IEEE Std 16-2004 review

The following document in a section by section review of the IEEE Std 16-2004. A brief description of each section is provided (Please refer to the IEEE Std 16 for the exact text). Commentary notes have been incorporated as follows:

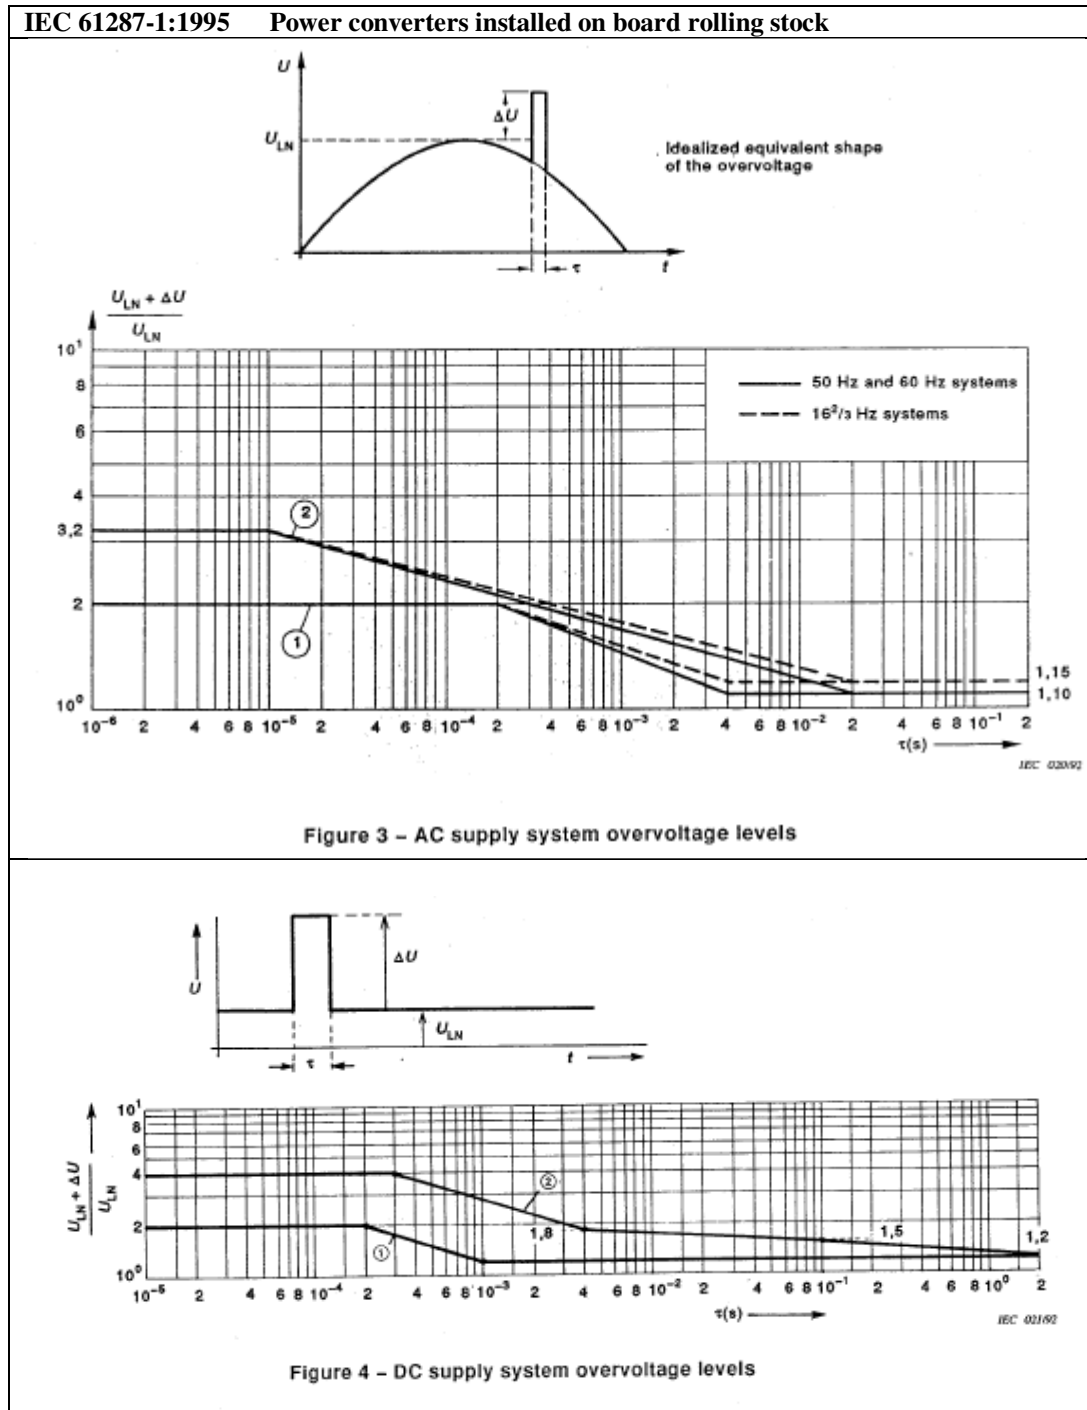
4.3 Electrical Transient		
Test	4.3.1.1	AC system supply overvoltage and time duration per Figure 3 of IEC 61287-1:1995 (Curve 1 normal operation), (Curve 2 no damage)
Test	4.3.1.1	DC system supply overvoltage and time duration per Figure 4 of IEC 61287-1:1995 (Curve 1 normal operation), (Curve 2 no damage)
